ABINGTON TOWNSHIP

BOARD OF COMMISSIONERS WORKING SESSION

- a. Presentation of the Preliminary/Final Major Subdivision and Land Development for LD-23-03 - 1583 Rothley Avenue.

RE: Executive Summary for LD-23-03-1583 Rothley Avenue
PARID: 30-00-60076-00-5/ TMID: 30200 002
PARID: 30-00-60072-00-9/ TMID: 30200 003
Preliminary/Final Major Subdivision & Land Development Plans Review (2nd Submission)

CONSTRUCTION DETAILS
OF
1583 ROTHLEY AVENUE
PREPARED FOR
DOLSON, LLC
ABINGTON TOWNSHIP, MONTGOMERY COUNTY, PA.

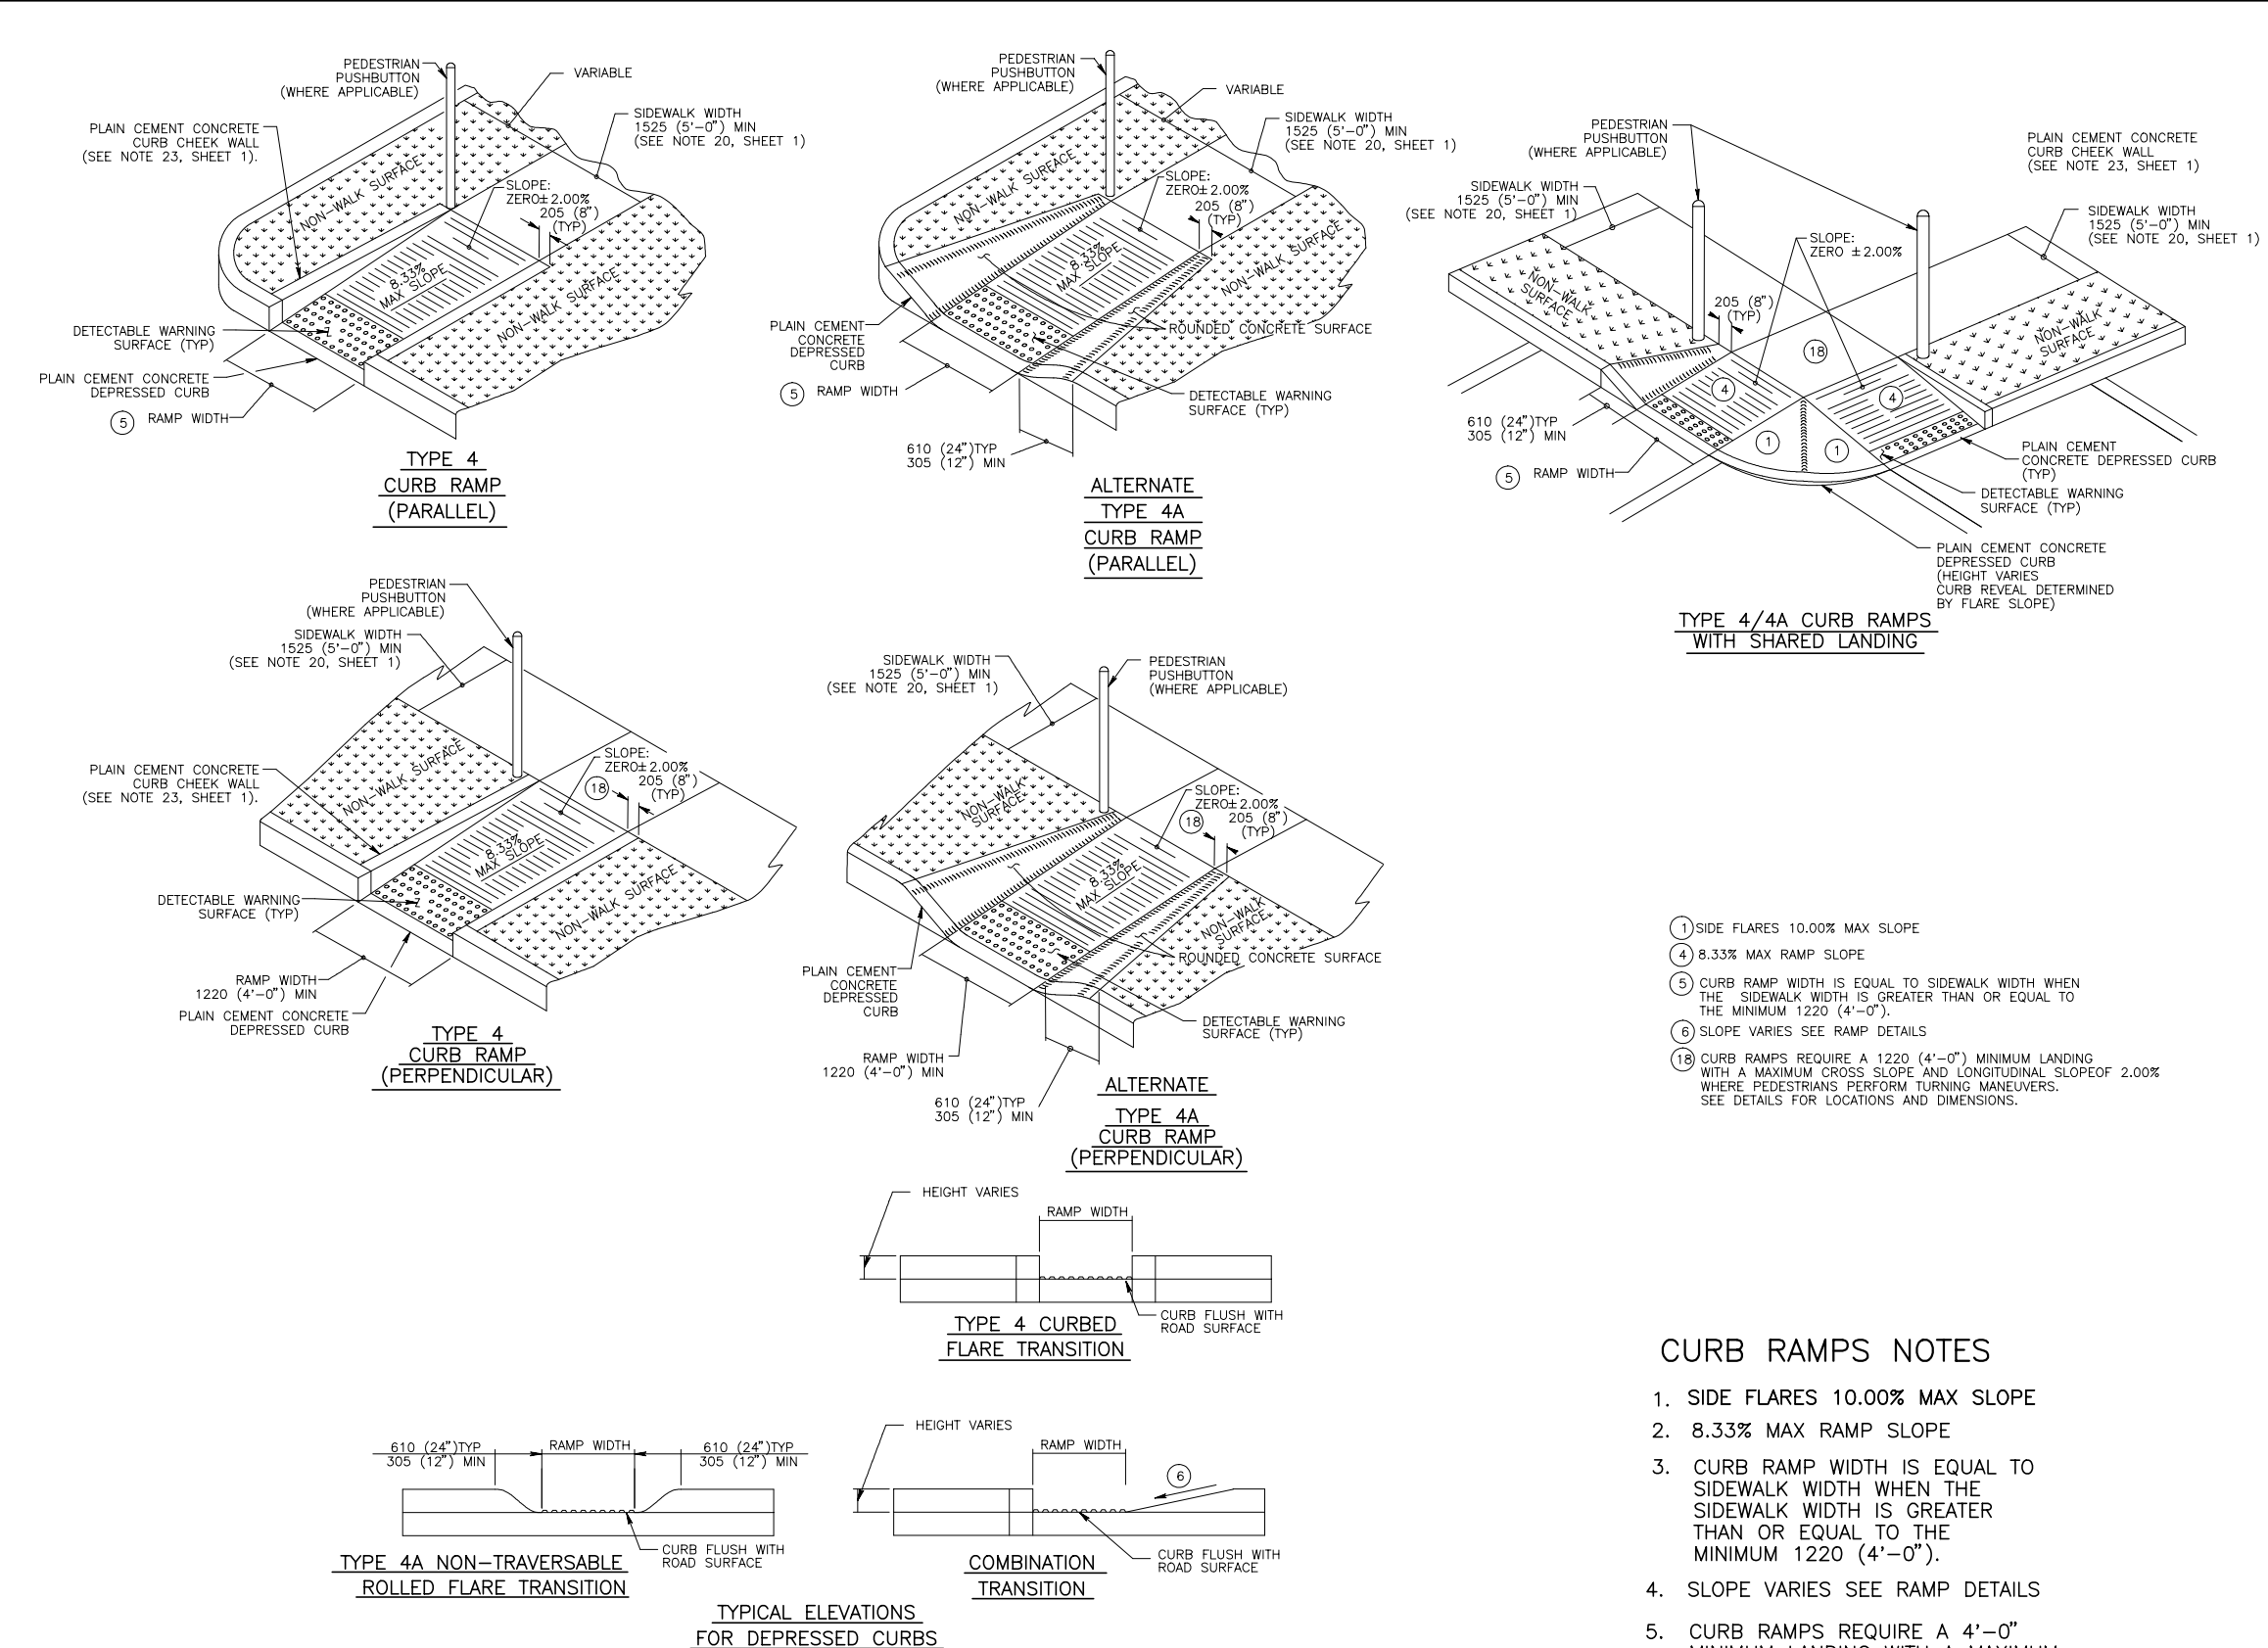
42. The seepage bed detail shown on the Construction Details (Sheet 10) shall indicate the 100-year storm elevation to ensure that the runoff volume from the storm event will be adequately captured by the proposed seepage bed.
